**RFP Title: BUILDING RENOVATIONS & HVAC INSTALLATION AT RWP GATEWAY GARAGE**

**Addendum #: 3**

**Issue Date: 12/18/2025**

**HVAC PROPOSED FOR REFERENCE**

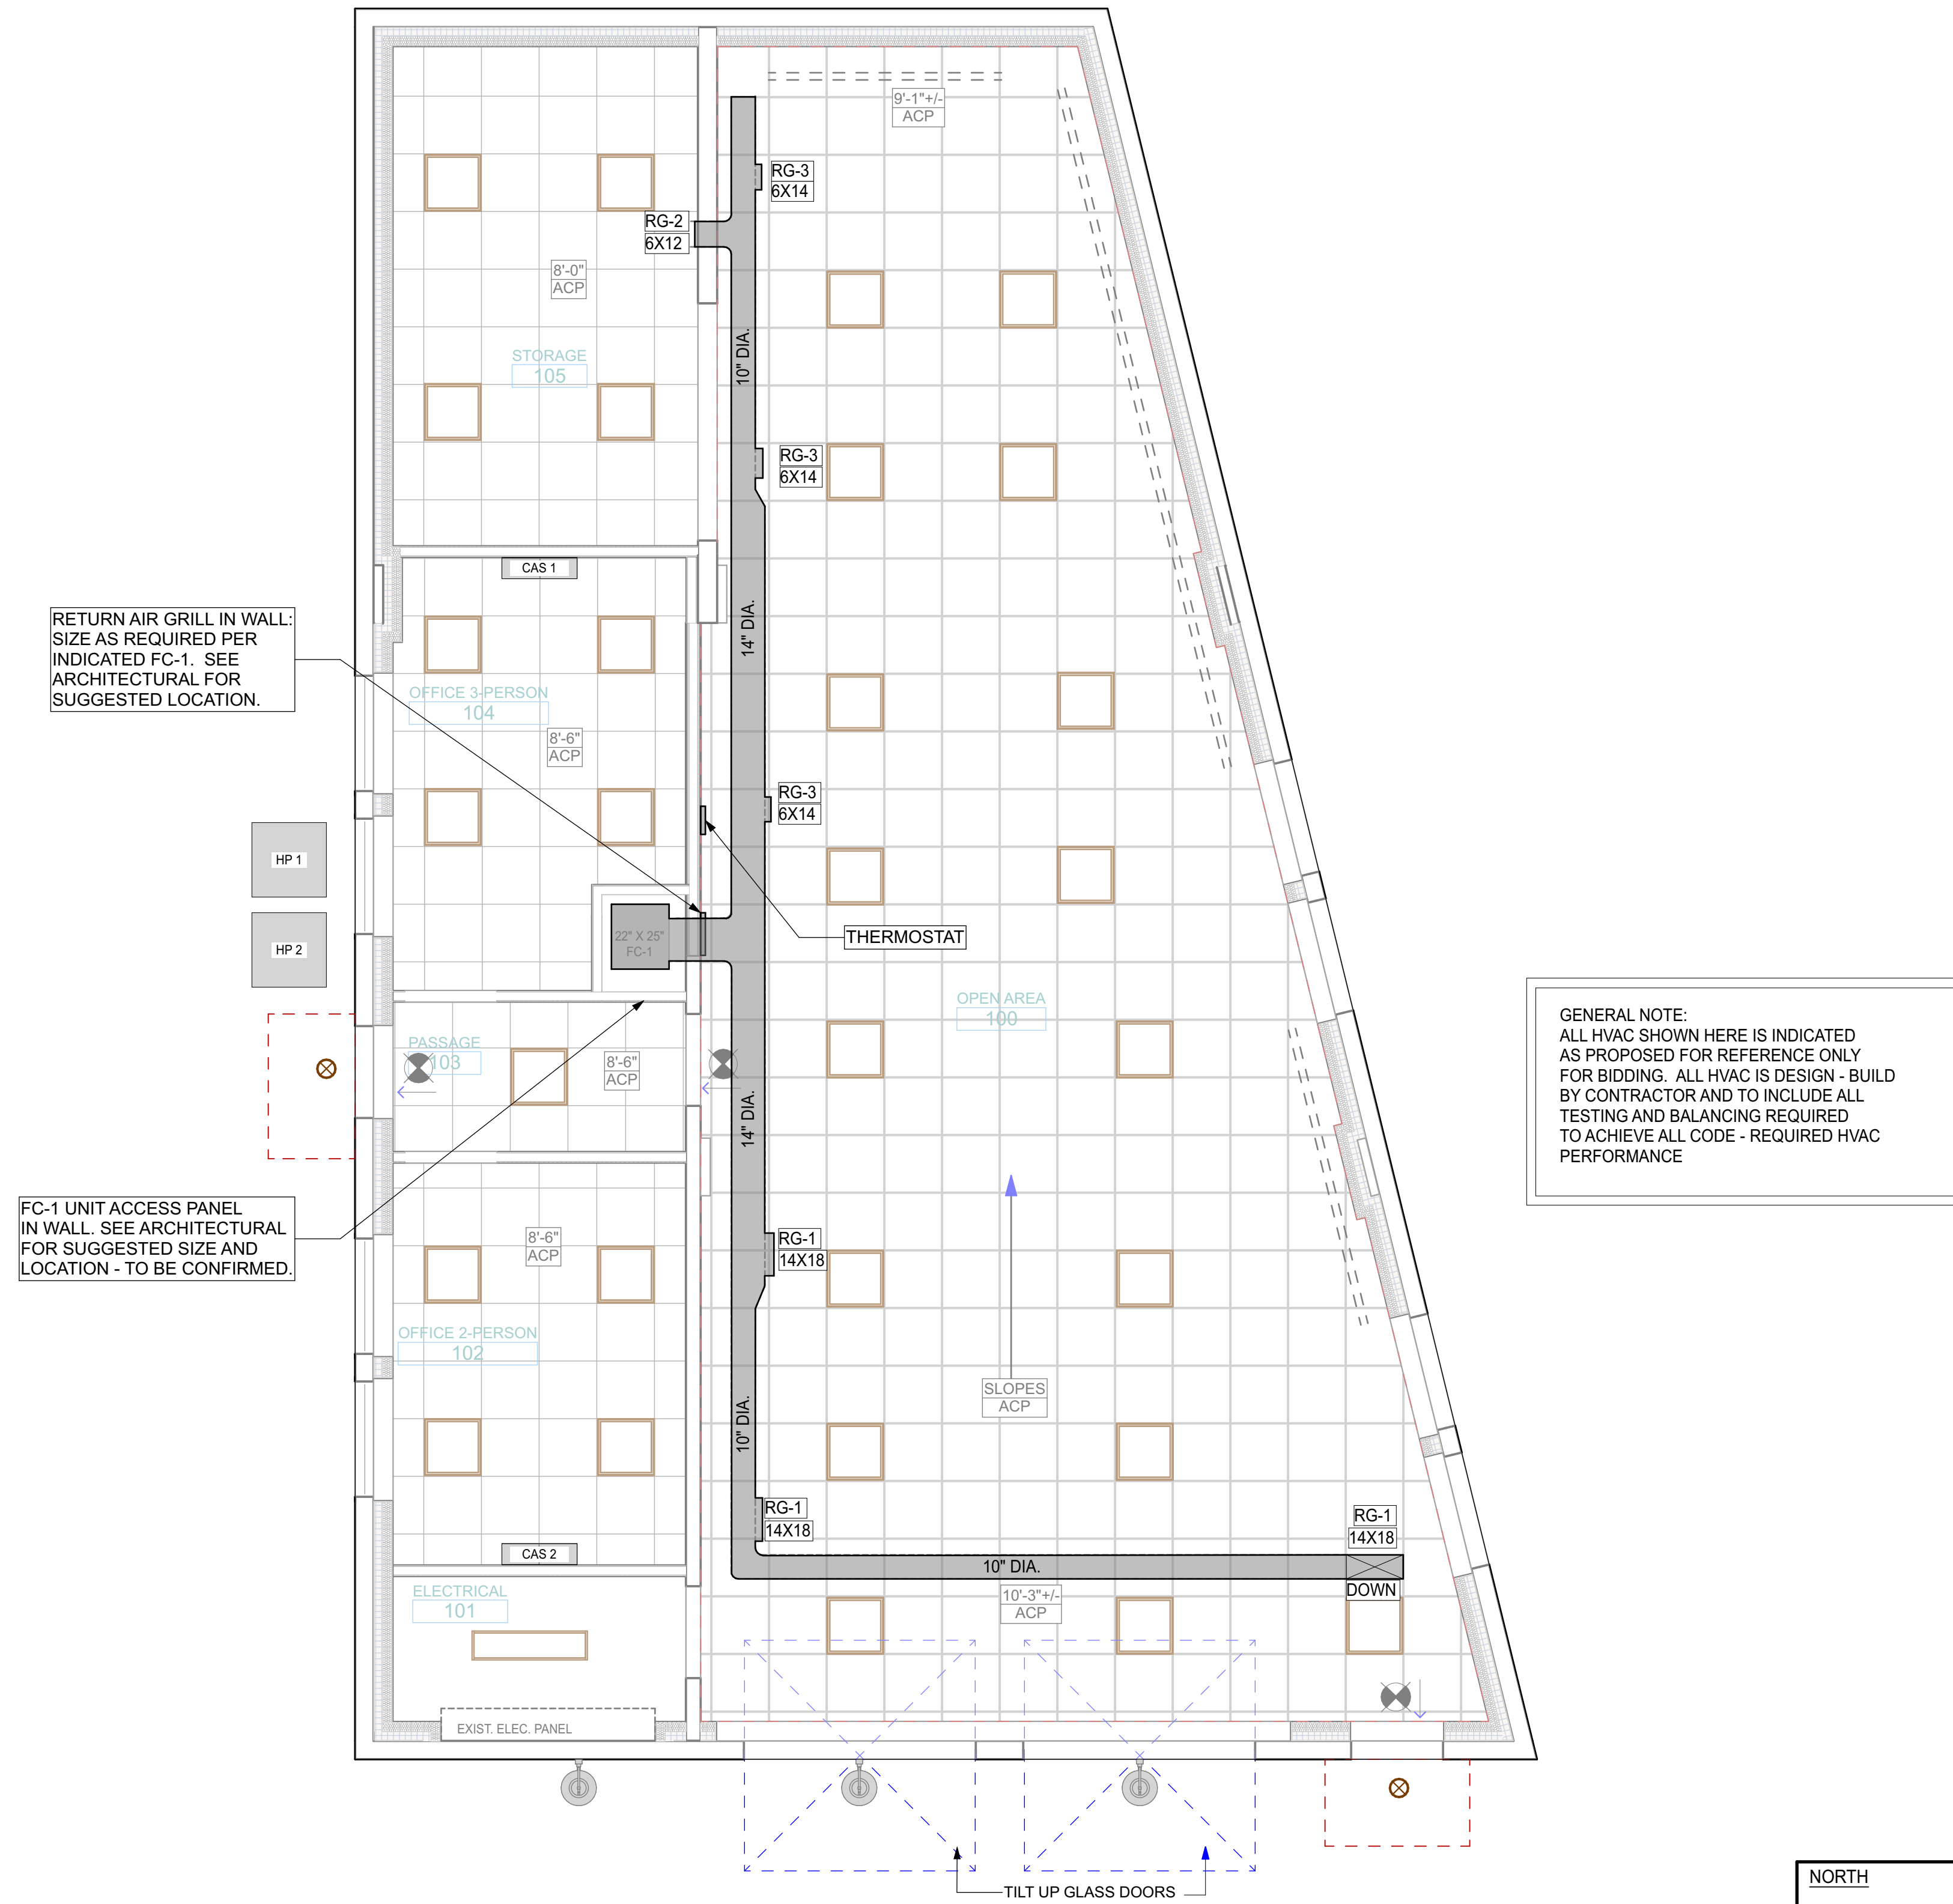
**18. Q: Is the HVAC system is fully design-build by the contractor? Which governs for bidding if there is a conflict between H-101 and the RFP/specs.**

**21. Q: Please confirm final locations and sizes for the FC-1 access panel and return grille, and required service clearances?**

*A: HVAC is fully design-build, with H-101 provided as a framework for the design, H-101 takes precedent over the Specs.*

*A: Locations shown are final. Required clearance between unit and service panel is 24" if adjustments to walls are needed to accommodate this clearance, the cost will be covered by the allowance.*
